DATE: April 27, 2026
TO: Scott Watson
Historic Preservation Officer
City of Riverside
SUBJECT: HH&IC PROJECT SOIS ANALYSIS - HARADA HOUSE

JMRC is the Architectural Historian of Record for the Harada House and Interpretive Center (HH&IC) Project, under contract to Kritzinger+Rao (Architect), to provide historic preservation consultation for both phases of the project from conceptual design through completed construction.

SUBJECT: HH&IC PROJECT DESIGN CONSULTATION - HARADA HOUSE ACCESSIBILITY

SUBJECT: HH&IC PROJECT DESIGN CONSULTATION - HARADA HOUSE EXTERIOR DOORS AND BUG SCREENS

Screened Porch

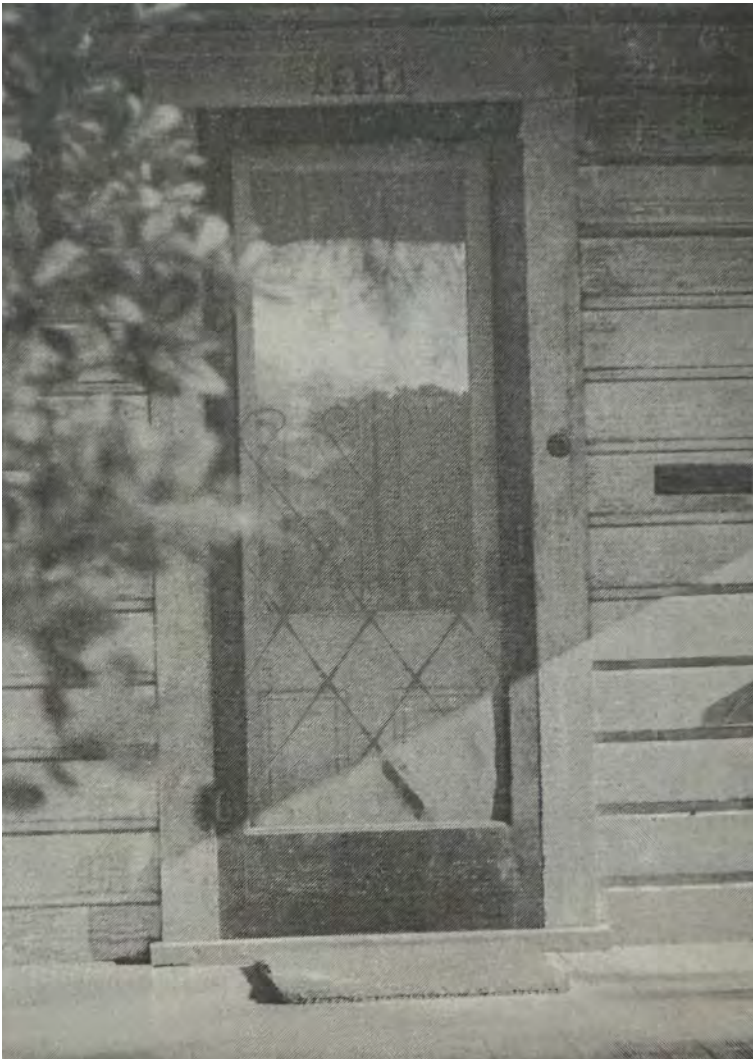
Existing Doors

The softwood door has three horizontal panels below one glass panel; some decorative wood graining is extant. Hardware includes a ferrous metal lock set with mortised strike plate, round metal doorknobs, and a bolt lock and simple ferrous metal hinges.

Existing Screens

Historic screen doors with two horizontal panels below a large mesh screen formerly noted in good to fair condition - one is extant, and the matching screen door may be in storage. Hardware includes ferrous metal, surface mount spring hinges, a metal hook and loop receiver attached to the stile and door casing, respectively.

Recommendation

In consultation with the Architectural Historian of Record, historic doors, screen doors, and extant hardware should be further assessed for material integrity by a qualified contractor and restored, repaired, salvage reconstructed, or custom reconstructed to match, as needed. Hardware should be salvaged and restored for reuse to the extent possible. If found in storage, the missing screen door should be reinstalled. If not located, a new screen door should be custom reconstructed to match and fitted with matching historic or new period-appropriate hardware.

Early 1900s cast iron cold air return floor grates

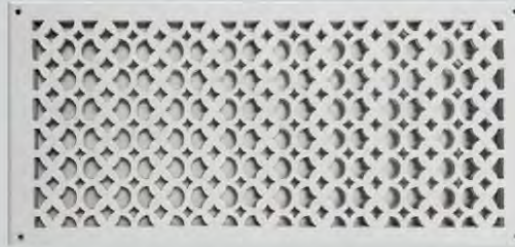
Although the association of the Harada family with the house began in 1915, the ca. 1884 residence would have retained many Victorian details then and throughout their association. Where grilles are being newly introduced, procurement of new, period-appropriate, rather than salvaged historic, vents in cast iron (most appropriate), brass, or bronze is recommended. Design should be in keeping with the late-Victorian period through the first decades of the 20th century, ideally featuring any one of the following motifs, without particular preference:

1. Single, simple geometric shape in tight formation
2. Looser central geometric, botanical, quatrefoil, or other pattern surrounded by a simple, tighter-pattern geometric
3. Integrated composition of two or more geometrics

Harada House ca. 1932 Showing Eave Trough Gutters

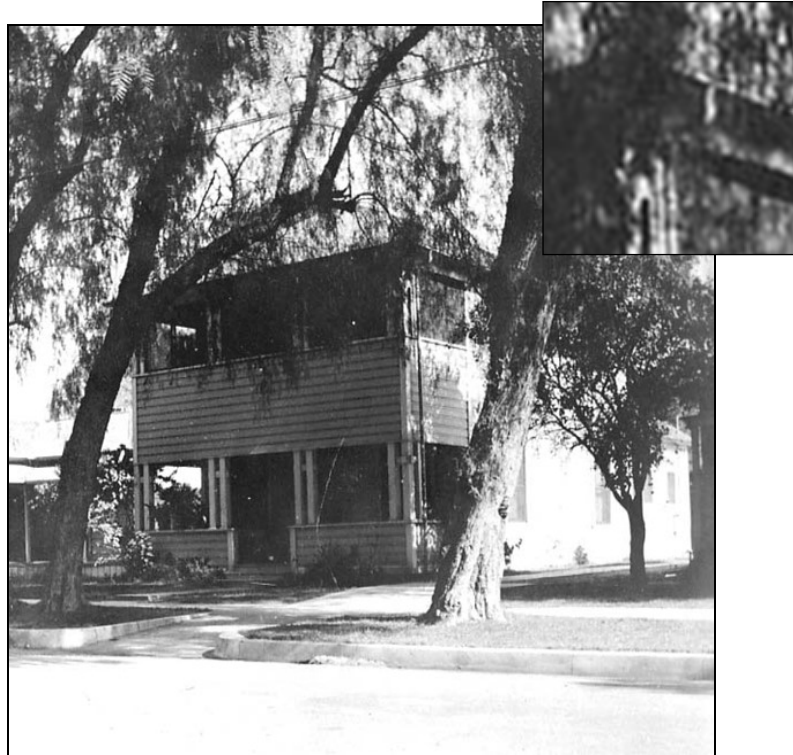
It is unlikely the Harada House had gutters originally as they are not visible in the newspaper photograph of the one-story house form. The contract for the second story addition commissioned by the Harada family in 1916 was not available for review; however, gutters were installed by ca. 1932. Closer examination of the ca. 1932 historic photo reveals that these ca. 1916-1932 gutters were the hanging eave trough type. Copper gutters and downspouts would have been out of place on such a modest home, suggesting these were likely galvanized iron or steel, tin, lead plated copper, or terne (tin/lead) and painted or unpainted.

The basic box type (in general, K-style) that we use today, and the one on the Harada House now, are similar to the historic box ones integrated into roof/cornice but began being hung from the eaves in the mid-1940s at the very earliest and became common by 1960, or no earlier than mid-1950s. Photo evidence in Rawitsch 2012 show this gutter type was installed by 1976; it was these gutters that likely replaced the first 1916-1930s iteration of hanging eave trough gutters. This later aesthetic also appears to have been the prototype for the 2006 replication effort.

If existing gutters are in poor condition and require replacement, this presents an opportunity to elevate the overall period aesthetic and museum visitor experience by returning to the ca. 1916-1932 eave trough gutter. Gutter styles have changed very little in the last century, and half trough hanging eave type gutters are still manufactured. Modern metals, hanging mechanisms, seamless fabrication that minimizes welded joints, and factory painting or bonderizing will assist in returning a period aesthetic at reasonable cost and without causing a false sense of historicity or maintenance and durability difficulties.

- Half-round eave trough
- Standard gauge range (.032-.027)
- Galvanized steel or aluminum
- Factory coated to match eave trim color or to mimic unpainted gray metal
- 3.5-inch to 8-inch trough width, per Architect

- ½-inch single bead (not reverse) on outside edge
- Visible (preferred) or hidden (acceptable) attachment bracket
- Round downspout and accessories
